09-AFC-4

From: Joe Ciolek <jciolek@anrtccc.org>
To: Pierre Martinez <pmartine@energy.state.ca.us>
Date: 3/14/2011 10:38 AM
Subject: Fwd: Docket Number: 09-AFC- 4 Oakley Generating Station
Attachments: IMPACT on VINES p110.pdf; CEQA REVIEW 11-09-09.docx

OAKLEY GENERATING STATION PROJECT

Figure 2. Site Layout

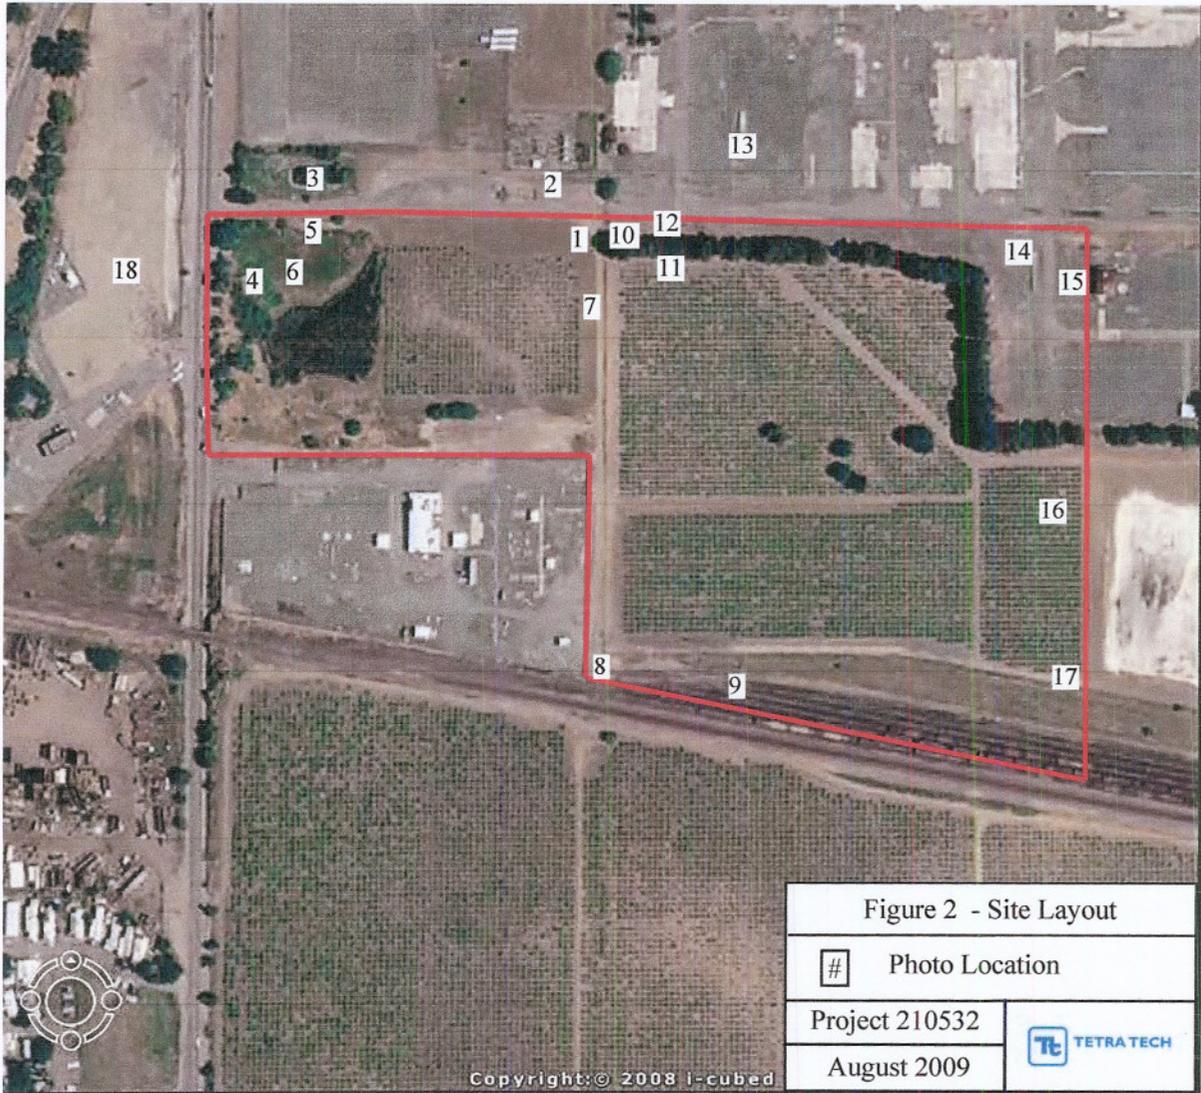
1. NOT in opposition;
2. Seeking to provide input to Radback, the City and the Commission regarding the unique heritage grape vines at the site (see attached map); and
3. Referencing portions of CEQA regulations (we understand that CEC follows its own process) we feel needed to be considered (see attached outline).

We continue to NOT oppose the project and comment again only to ask that the CEC consider what we believe is a significant impact on agricultural resources at the site. We note that much study and consideration has been given in the 90 page Biological Resources section of the FSA and that agricultural resources are mentioned simply as the single word "vineyard" only three times (if I am correct). Our concern is that Oakley (and east Antioch) has unique heritage grape vines and that the agricultural mitigation experience from another project in Oakley just the month before (10/1/2009) be thoroughly considered in deciding on this project. We have to believe that both Radback and the City have determined that the impact on agriculture is not a factor to be addressed specifically in the project, but suggest again that it be looked at more closely.
